# ENVIRONMENTAL REVIEW TEAM REPORT

Overbrook Farm  
Subdivision  
Stamford,  
Connecticut

Environmental Review Team Report

Stamford Environmental Protection Board

**CONCEPTUAL  
SITE PLAN**

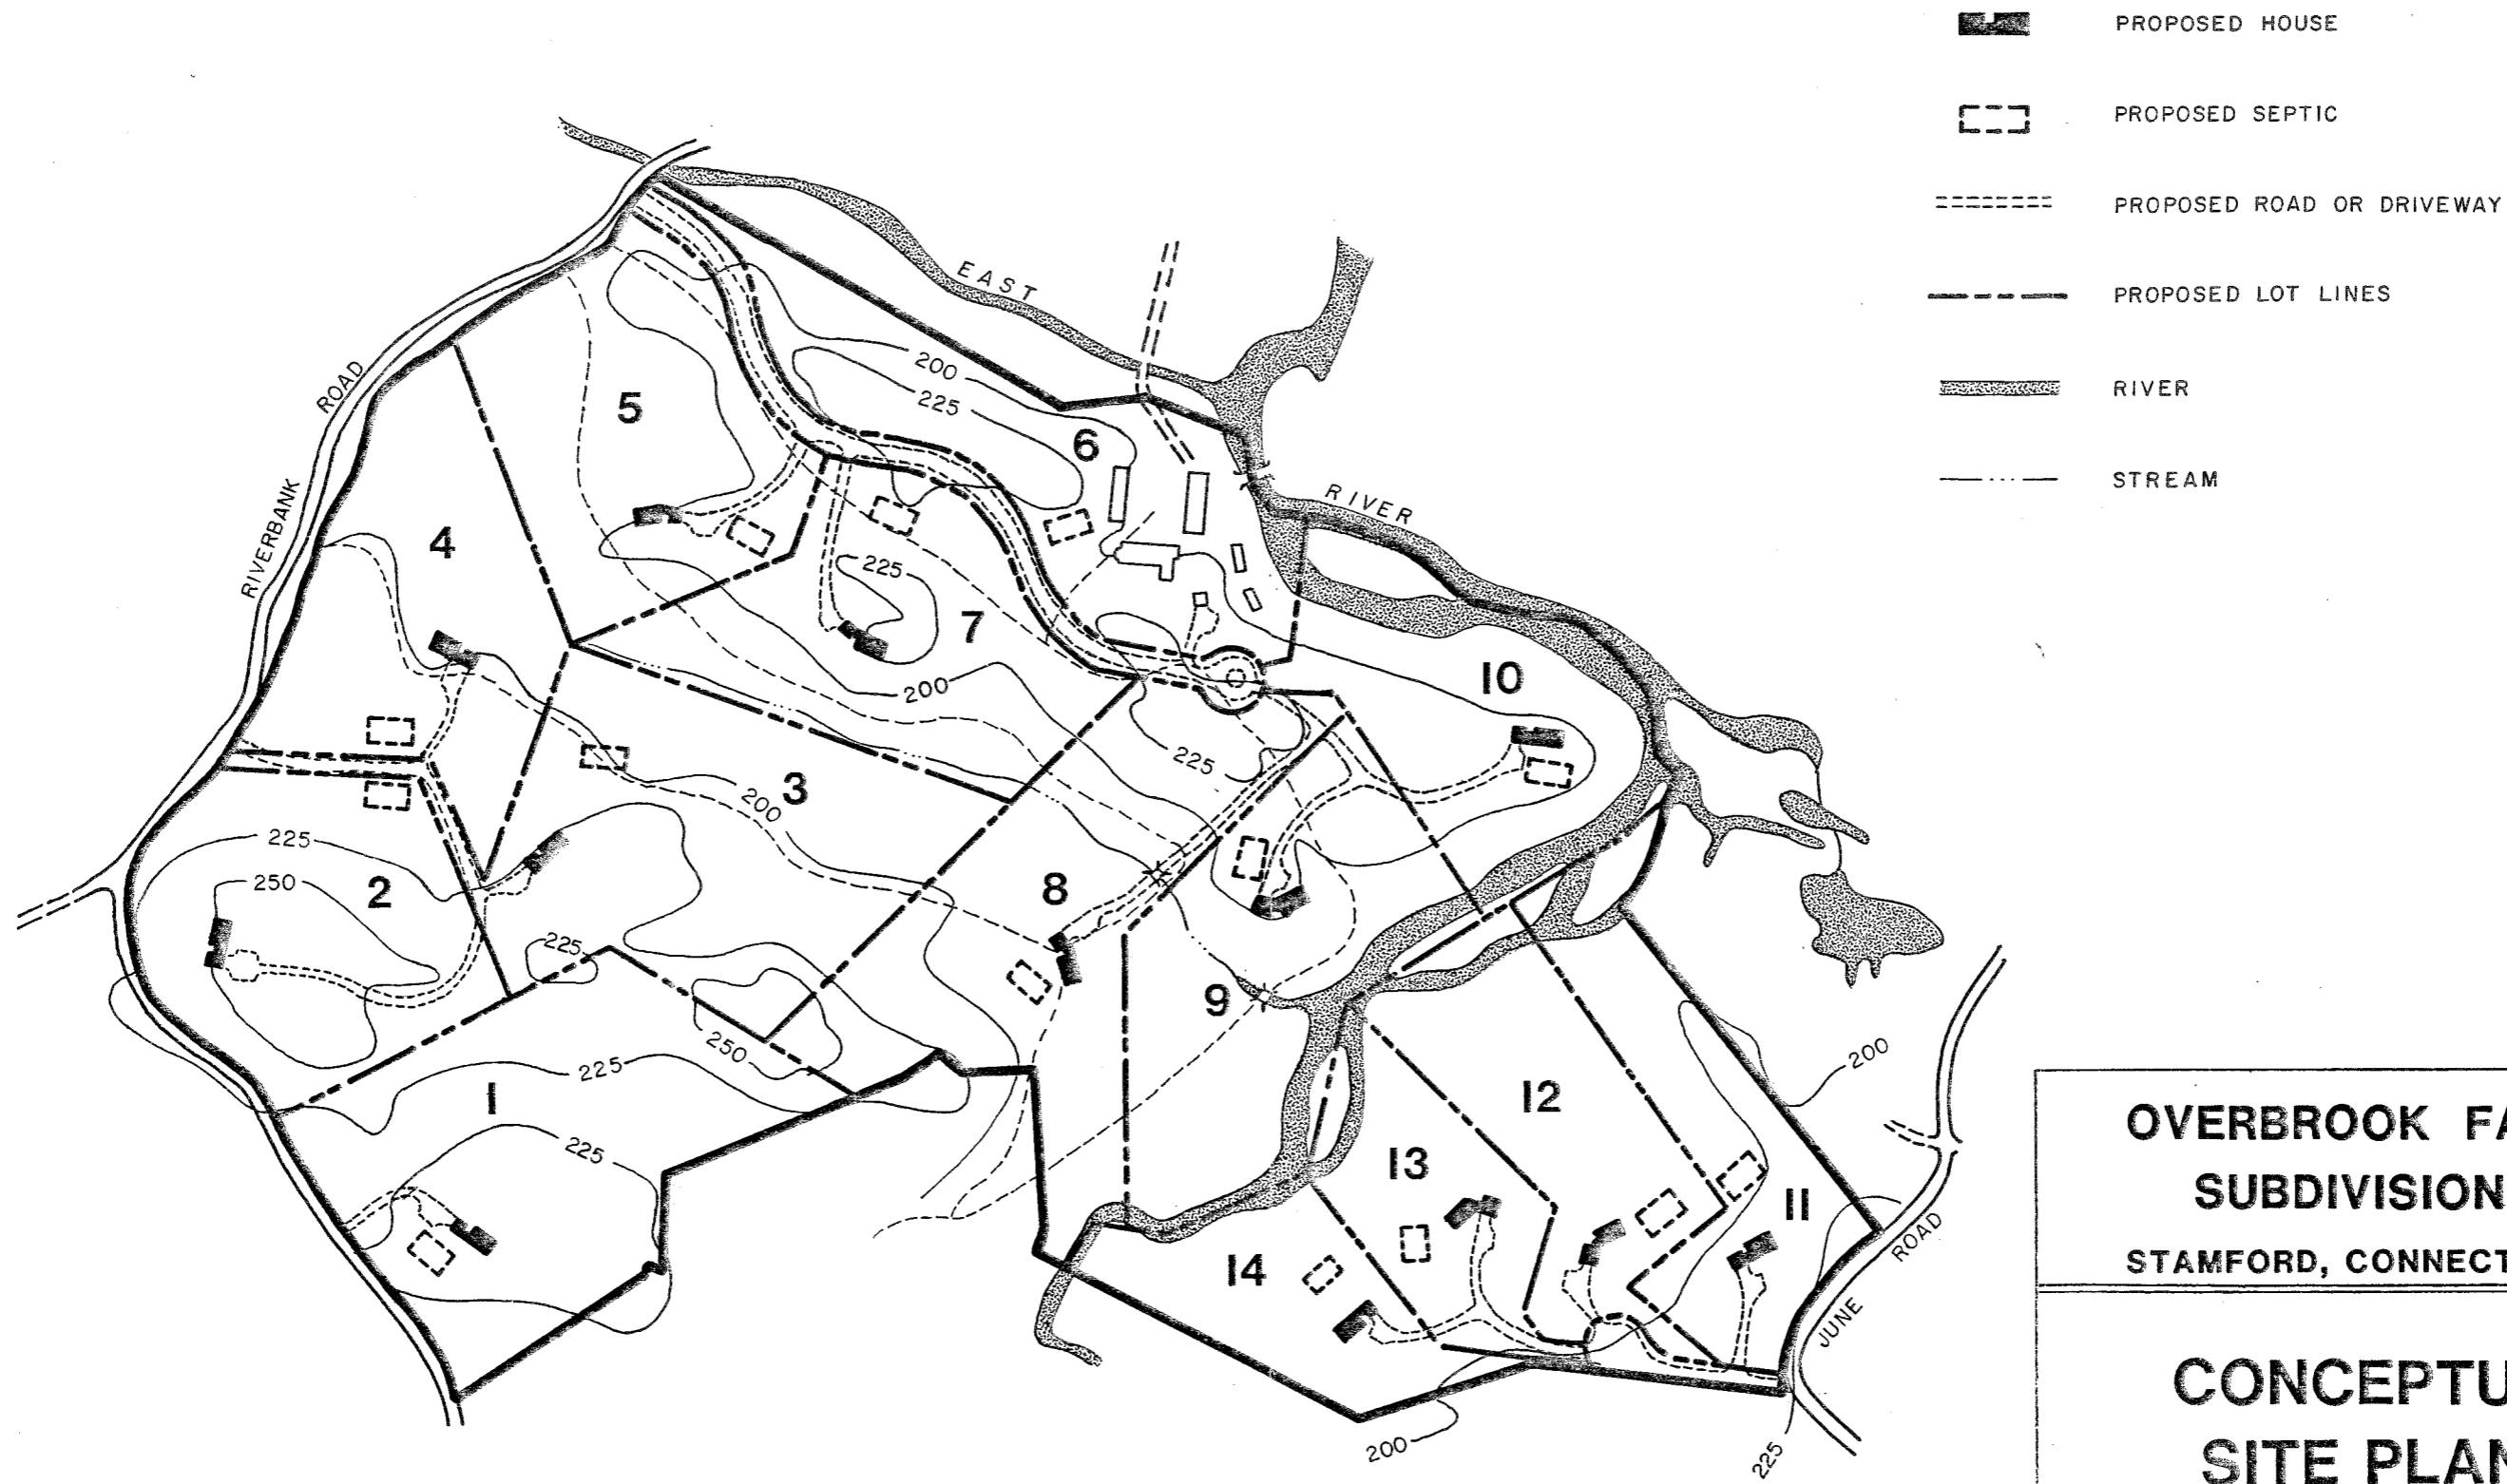
The wetland boundaries do not seem accurate on the western edge of Lot 7, the north western corner of Lot 3, and the eastern edge of Lot 6. Some of these differences may be because the plans reviewed (8/19/86) showed sketched wetland boundaries and not surveyed wetland boundaries.

Lots 4 and 8 have septic systems proposed on moderately well drained soils. Because of the size of the lots, it should be possible to locate the systems on well drained soils upslope.

The proposed septic system for Lot 2 will receive surface and subsurface runoff water from higher on the landscape. A "swale," curtain drain, or relocation should be considered.

The proposed development appears to be well planned and situated to minimize environmental impact to the wetlands and watercourses. The only impacted area is the driveway crossing across Salamander Creek, allowing access to Lot 8. This in itself does not present a real problem, however, since the crossing is at a narrow point; and if an adequate sized culvert is used, stream flow will not be obstructed during periods of high water. Therefore, the hydrology of Salamander Creek needs to be investigated prior to approval of the crossing.

The site is served primarily from Riverbank Road and June Road. Both roads are narrow and winding. Locations where the proposed road serving Lots 5 to 10 and the accessway serving Lots 2 to 4 were visually examined during the field review for site distances. It is suggested that the accessway for Lots 2 to 4 be shifted slightly to the east, to provide improved site distance from the west. The design of the new street intersection with Riverbank Road should insure that cars waiting to enter Riverbank Road and northbound cars on Riverbank Road wishing to turn left into new road be fully visible to approaching southbound traffic on Riverbank Road.

Figure 7

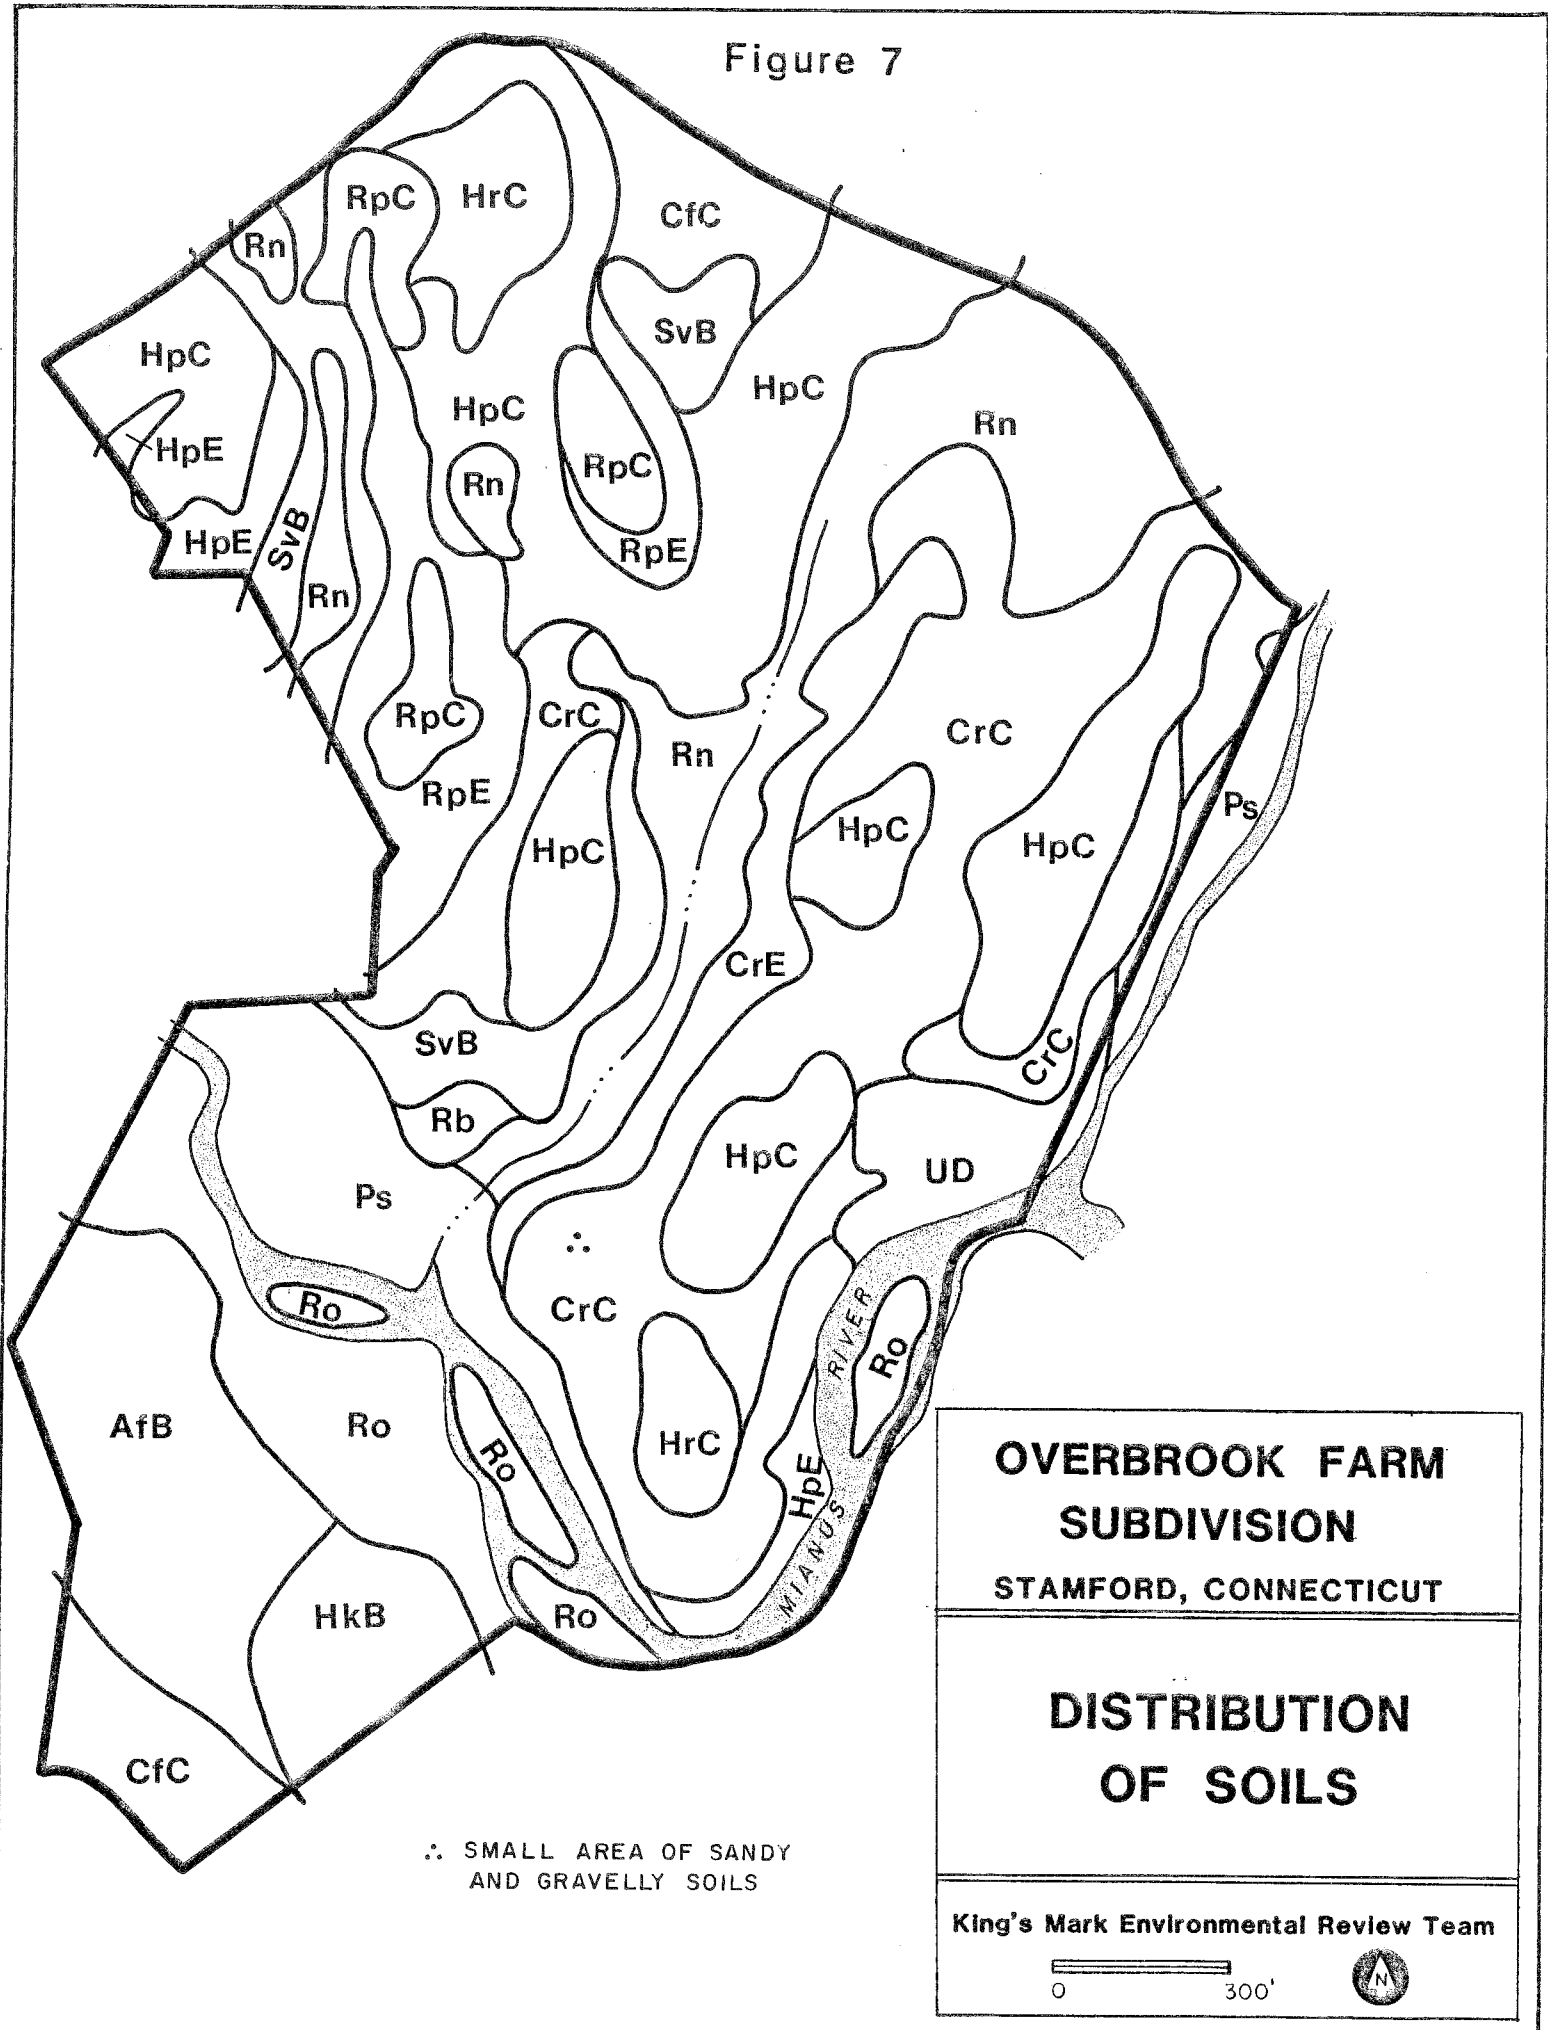
- (1) The soils map at 1" = 300' shown in Figure 7 should not be used in discussions about wetland values and acreage. The soil map prepared for the developer by a private soil scientist in general shows wetland areas and configurations that could not be shown at the scale of the enclosed map. The wetland boundaries do not seem accurate on the western edge of Lot 7, the north western corner of Lot 3, and the eastern edge of Lot 6. Some of these differences may be because the plans reviewed (8/19/86) showed sketched wetland boundaries and not surveyed wetland boundaries.
